APPLICATION FOR PERMIT TO DRILL		1. WELL NAME and NUMBER Greater Monument Butte 15-22-9-15H
2. TYPE OF WORK DRILL NEW WELL <input checked="" type="checkbox"/> REENTER P&A WELL <input type="checkbox"/> DEEPEN WELL <input type="checkbox"/>		3. FIELD OR WILDCAT MONUMENT BUTTE

WELL LOCATION, 15-22-9-15H, LOCATED AS SHOWN IN THE SW 1/4 SE 1/4 OF SECTION 22, T9S, R15E, S.L.B.&M. DUCHESNE COUNTY, UTAH.

The proposed Bottom Hole location for the above mentioned Horizontal APD has been changed. The new proposed Bottom Hole Footage will be 730' FSL 1380' FWL. SE/SW Sec. 27, T9S R15E. Attached find the new Plat, Cut Sheets, Drilling Program, and Direction Drill Plan reflecting this change. The remainder of the approved APD will remain the same.

WELL PAD INTERFERENCE PLAT

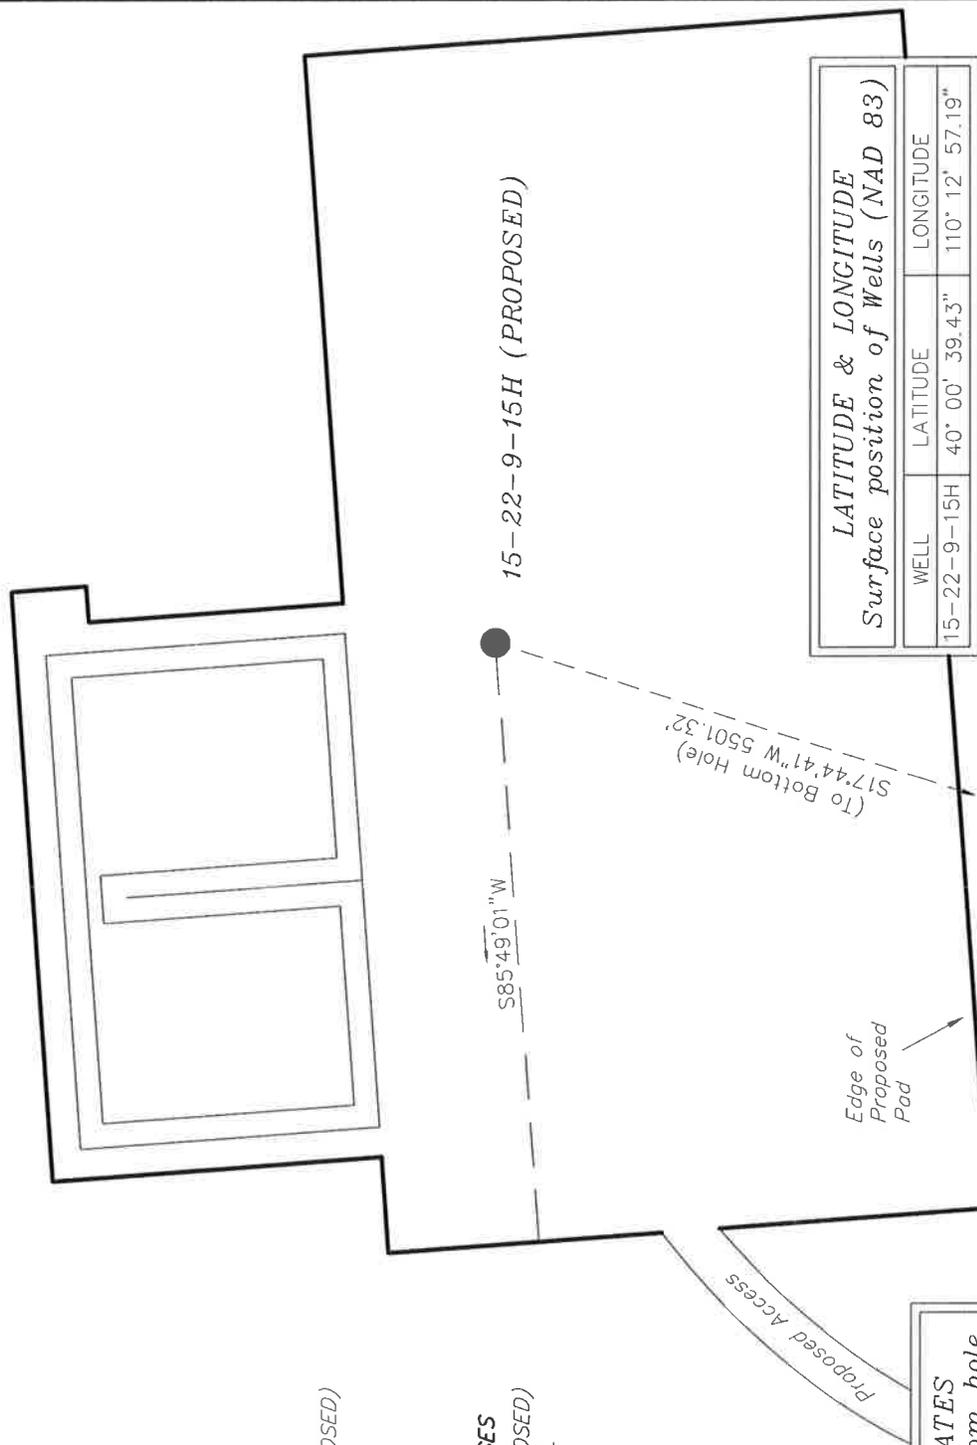
The proposed Bottom Hole location for the above mentioned Horizontal APD has been changed. The new proposed Bottom Hole Footages will be 730' FSL and 1380' FWL. SE/SW Sec. 27, T9S R15E. Attached find the new plat, cut sheets, drilling program, and directional drill plan reflecting this change. The remainder of the approved APD will remain the same.

15-22-9-15H (PROPOSED)
730' FSL & 1380' FWL

WELL LOCATION, 15-22-9-15H,
 LOCATED AS SHOWN IN THE SW 1/4
 SE 1/4 OF SECTION 22, T9S, R15E,
 S.L.B.&M. DUCHESNE COUNTY, UTAH.

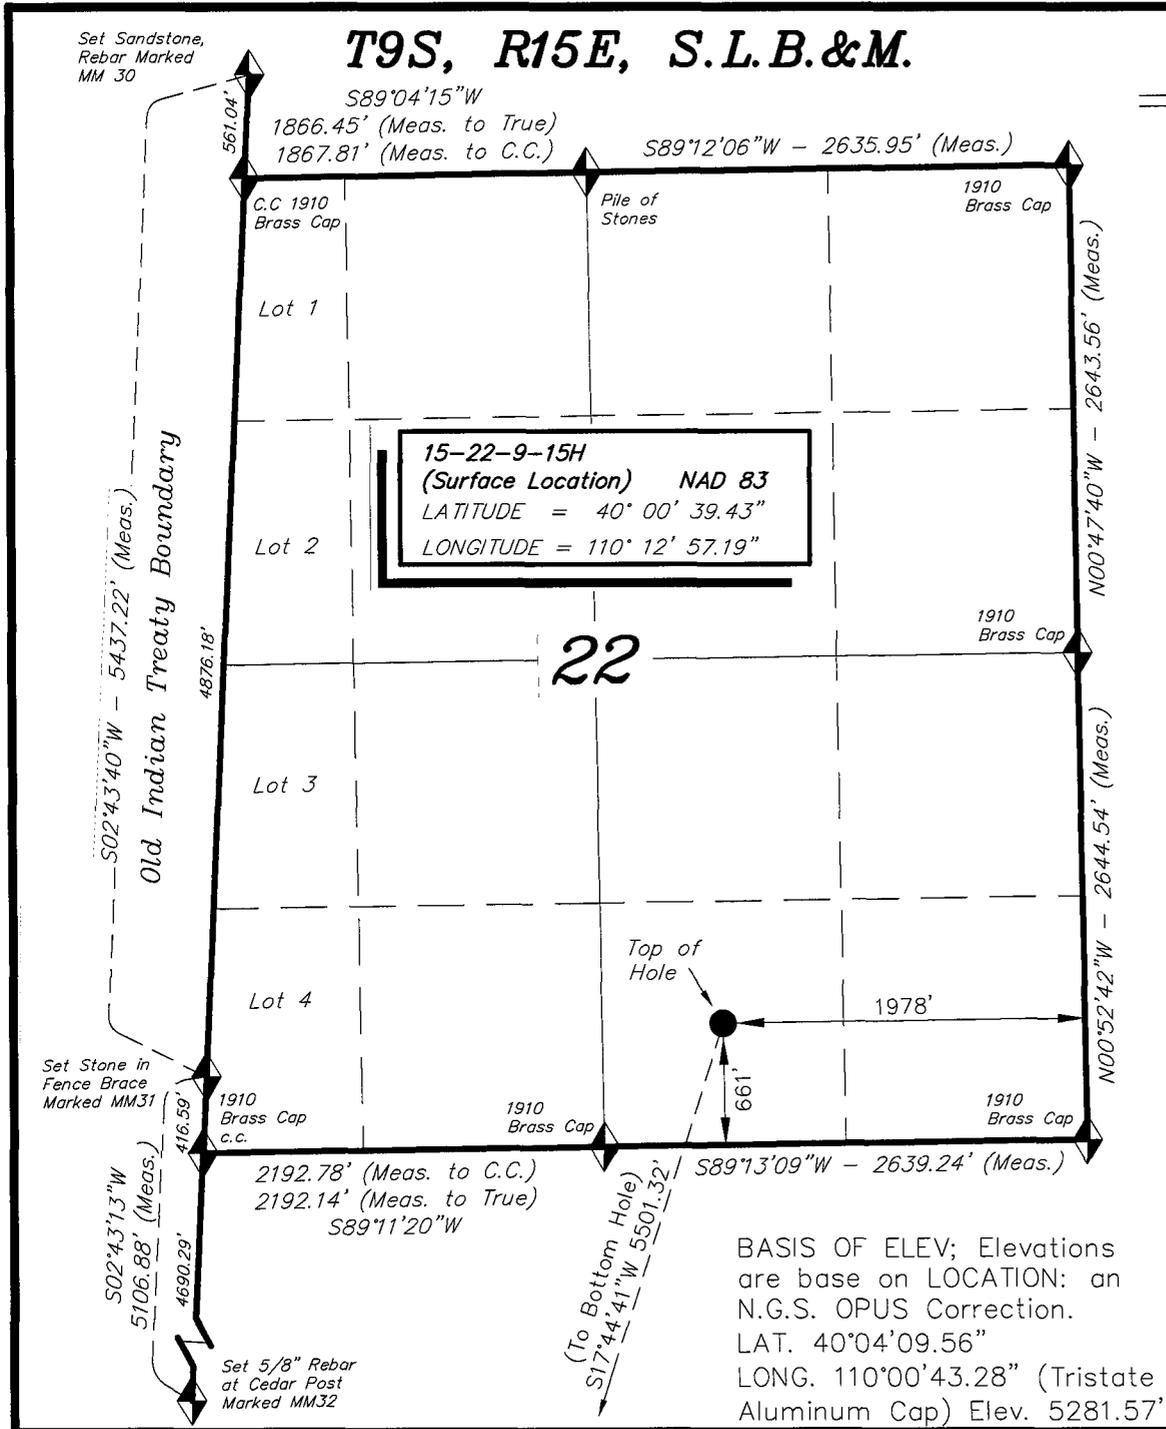
The permit for the above-cited well was for a well bore advanced to the northeast. The plat map I received from Jennifer on June 1 shows the well bore going southwest. Please submit an explanation for this well's bottom hole location and a letter of Exception Location to the Utah Division of Oil, Gas and Mining, to my attention. Thank you.

In reviewing this Well Completion Report, we need to amend what we submitted. We had revised the APD prior to drilling this well. I have attached that Approved APD Revision.
